Addendum No. 2
To the Plans and Specifications of

Escambia County Fire-Rescue
Paradise Beach – Station 20
1250 Bauer Road
Pensacola, Florida

Four Pages + Attachment(s)
August 4, 2026

⚠ **STORMWATER LIFT STATION ELEVATION** N.T.S.

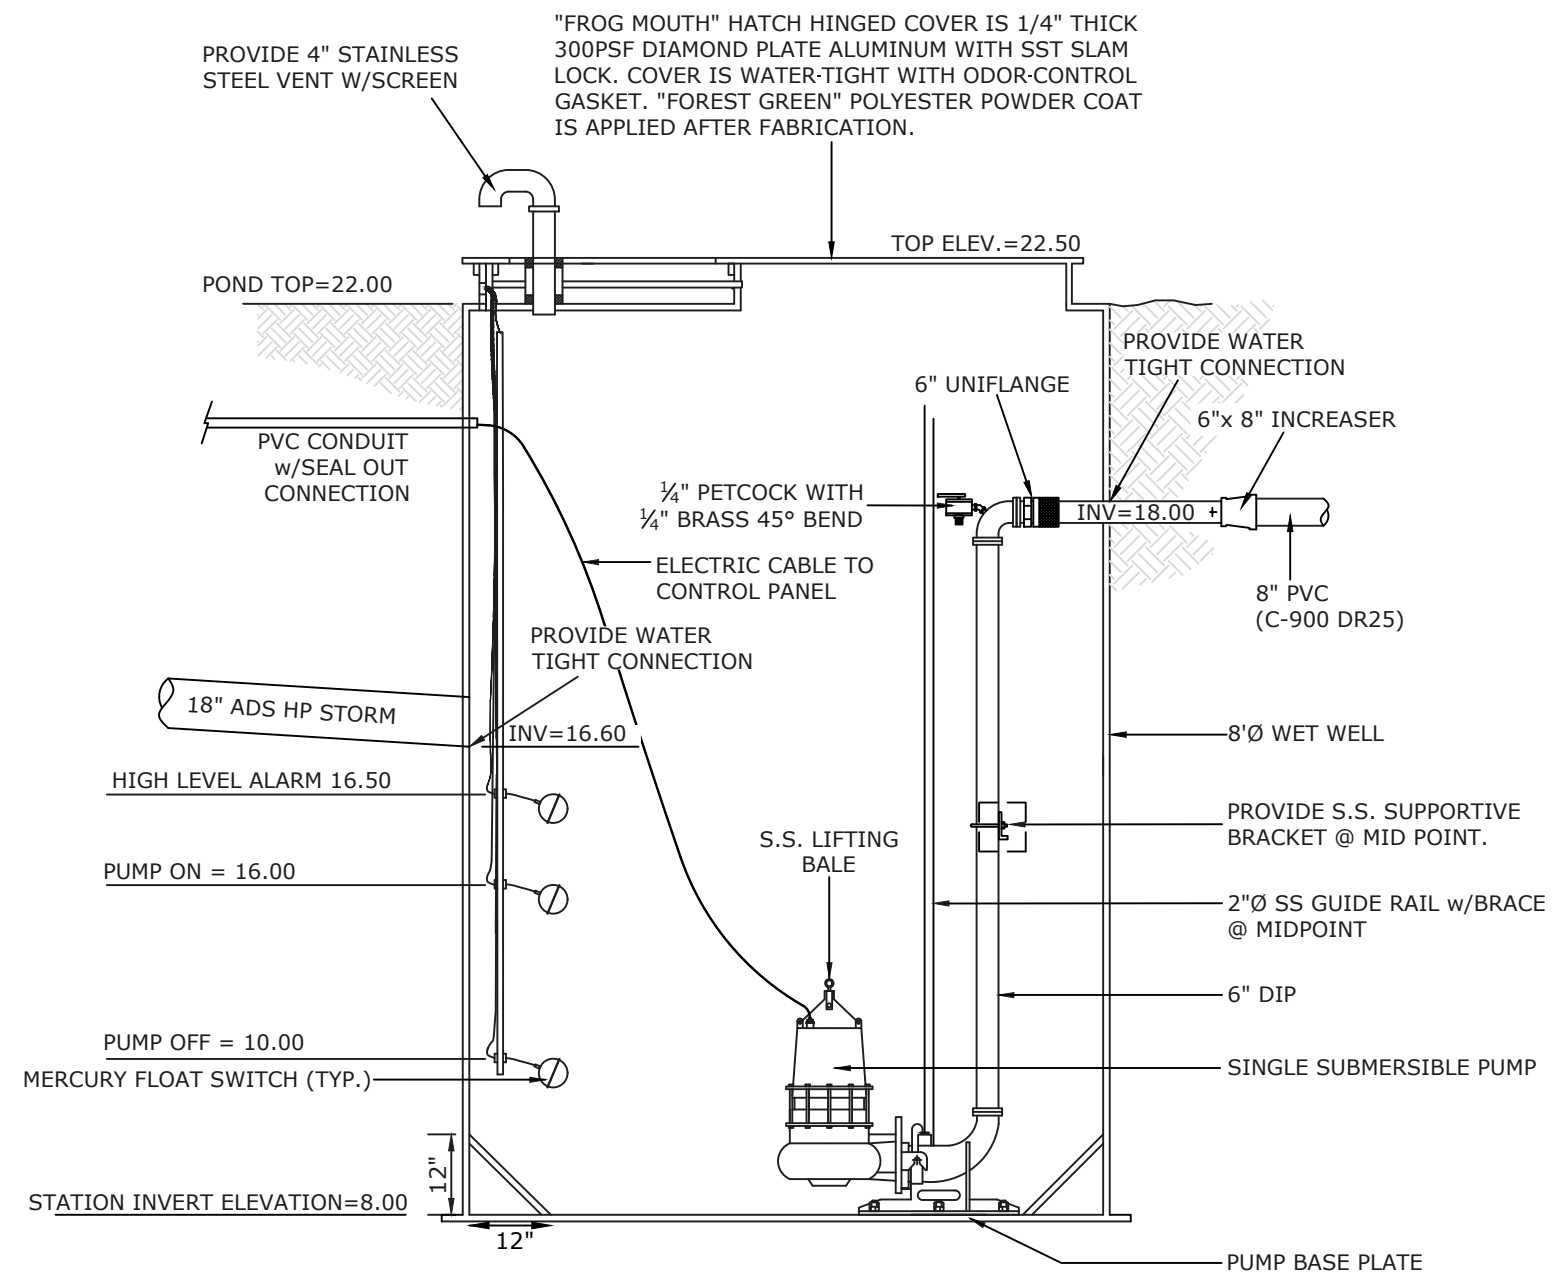
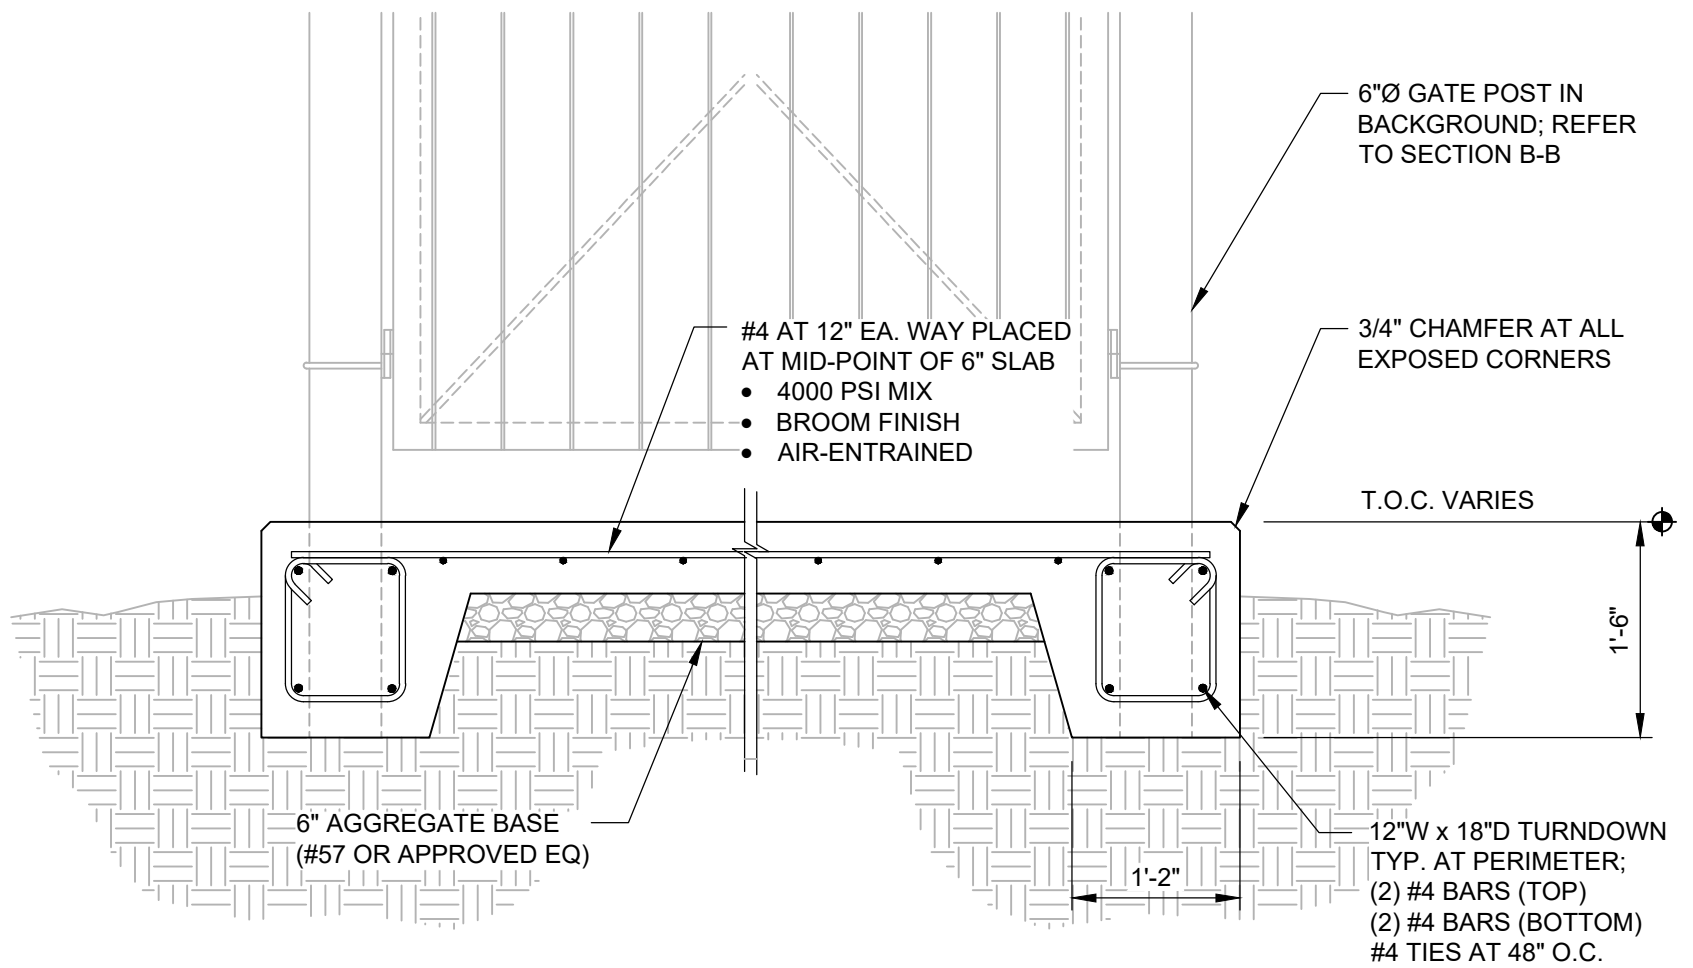
11. Sheet C-705 – Added stormwater pump station details, see attached.

TYPICAL SECTION AT DUMPSTER PAD TURNDOWN

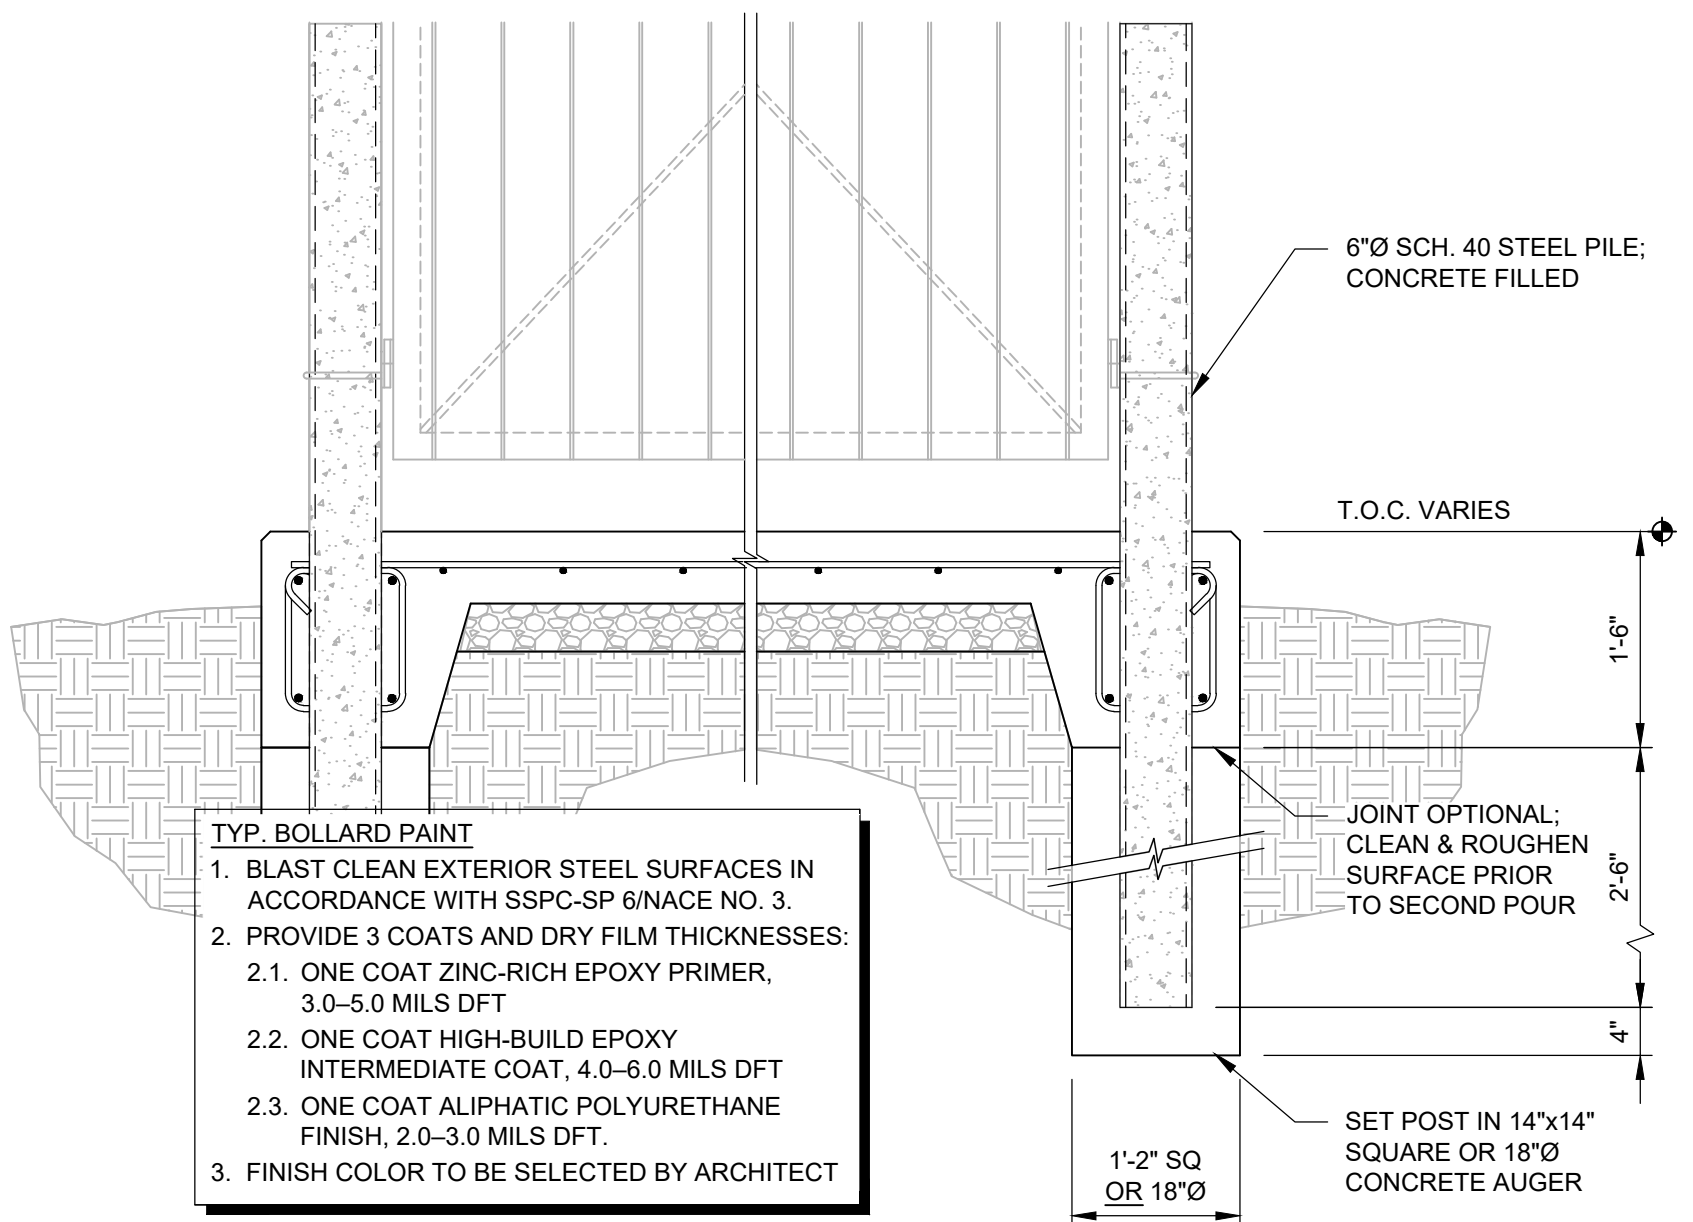
- S1. Sheet S001 – At design loads section, wind speed is to be changed to 180 mph.
- S2. Dumpster pad foundation – See enclosed new dumpster pad foundation drawings.
- S3. Sheet S102 – The living area left of column line C has a 4" thick slab. The apparatus bay right of column line C has an 8" thick slab.
